# UNITED STATES PATENT AND TRADEMARK OFFICE

APPLICATION NO.	FILING DATE	FIRST NAMED INVENTOR	ATTORNEY DOCKET NO.	CONFIRMATION NO.
10/613,842	07/03/2003	Daryl E. Anderson	200208831-1	6766

<b>Office Action Summary</b>	<b>Application No.</b> 10/613,842	<b>Applicant(s)</b> ANDERSON ET AL.	
	<b>Examiner</b> Michael G. Bogart	<b>Art Unit</b> 3761

## DETAILED ACTION

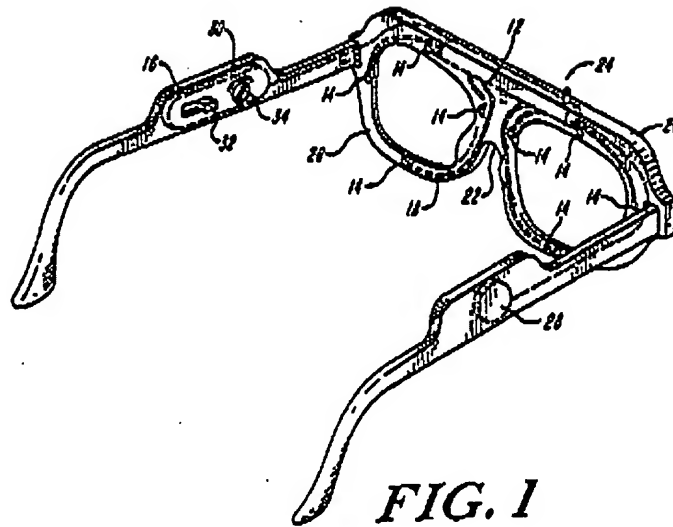
Bertera teaches a spectacle style frame that includes means for introducing fluid to the eyes of a wearer (see figure 1, *infra*).

At the time of the invention, it would have been obvious to one of ordinary skill in the art to combine the frame member of Bertera with the dispensing mechanism of the '057 application in order to provide a means for holding the mechanism in place in front of a wearer's eyes.

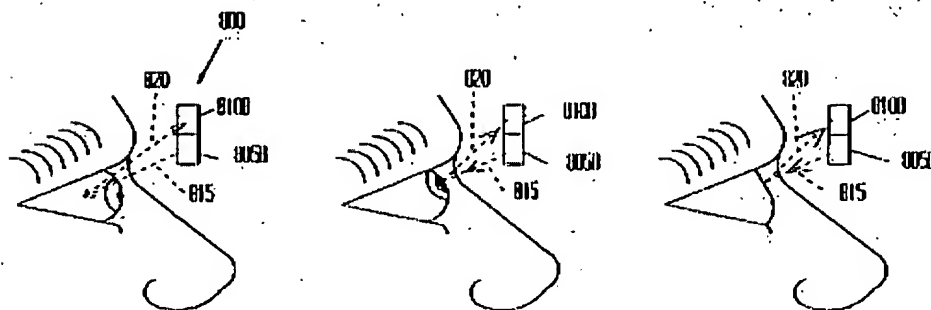
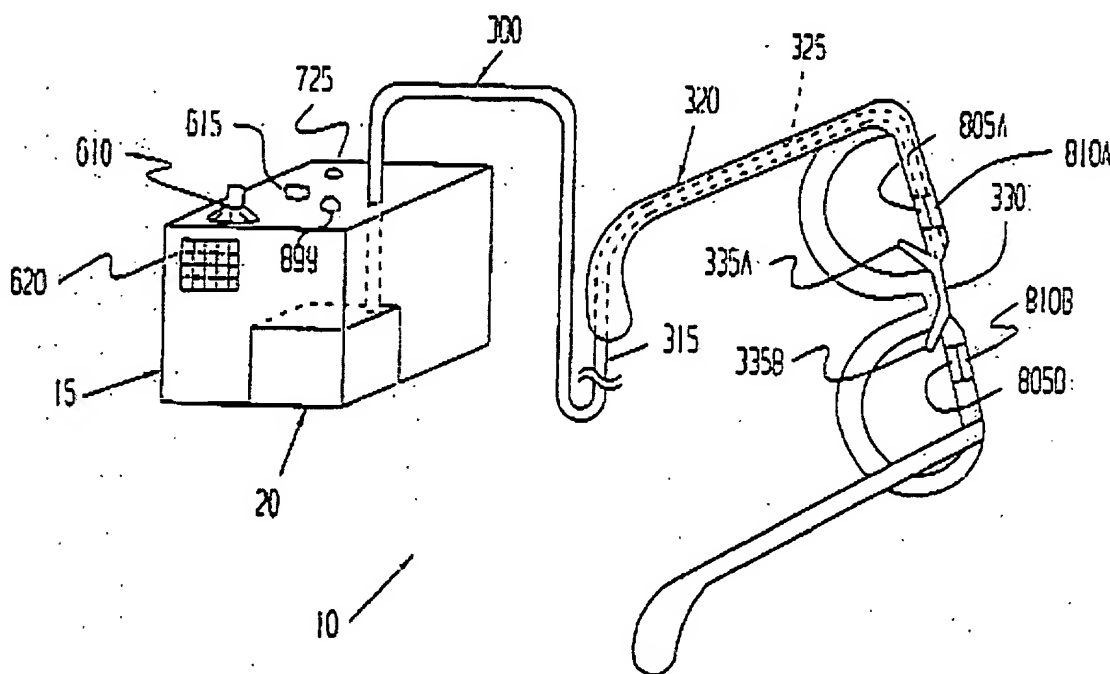
Vo teaches a spectacle frame style eye drop delivery system (10) that detects an eyes position relative to a dispensing apparatus (320)(col. 8, line 65-col. 9, line 30)(see figures 1 and 6A-6C, infra). This permits dispensing of eye drops only when the eye is positioned in a disadvantageous position.

At the time of the invention, it would have been obvious to one of ordinary skill in the art to combine the frame member and eye position detection means of Vo with the dispensing mechanism of the '057 application in order to provide a means for holding the mechanism in place in front of a wearer's eyes and to avoid dispensing of eye drops when the eye is positioned in a disadvantageous position..

FIG. 11

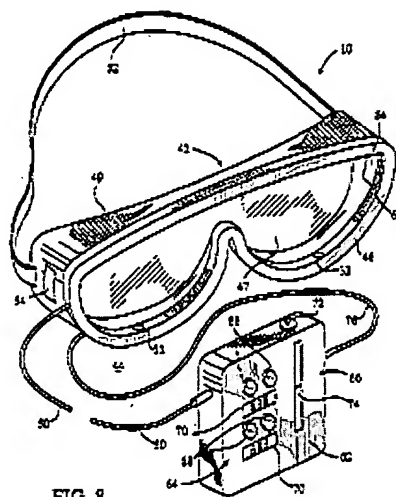
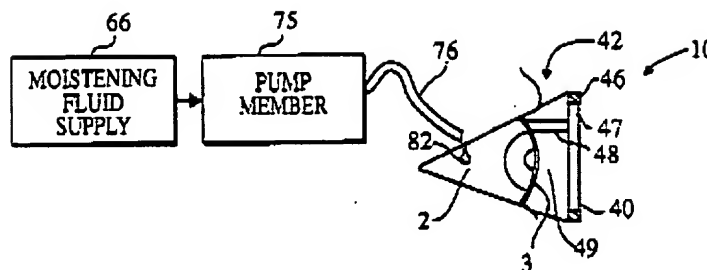
Regarding claims 1, Yee teaches an eye-positioning device (10) capable of assisting a subject in positioning an eye (2)(to an open or closed position of the eye; also, the visual indicator on the monitor (6) can be used to draw a patient's focus); and

An applicator capable (60, 66, 75, 76) of dispensing fluid into an eye (2)(see figures 8 and 11, infra).

Regarding claims 9 and 10, Yee teaches a spectacle frame (40) and a fluid dispenser (60) supported by the frame (40)(figure 8).

FIG. 4

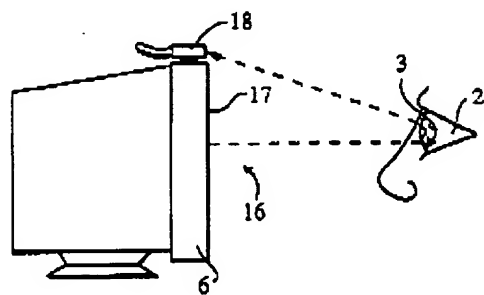
Regarding claim 5, Yee teaches a display monitor (6)(see figure 4, infra). A conventional computer display monitor is capable of displaying an image of an eye.
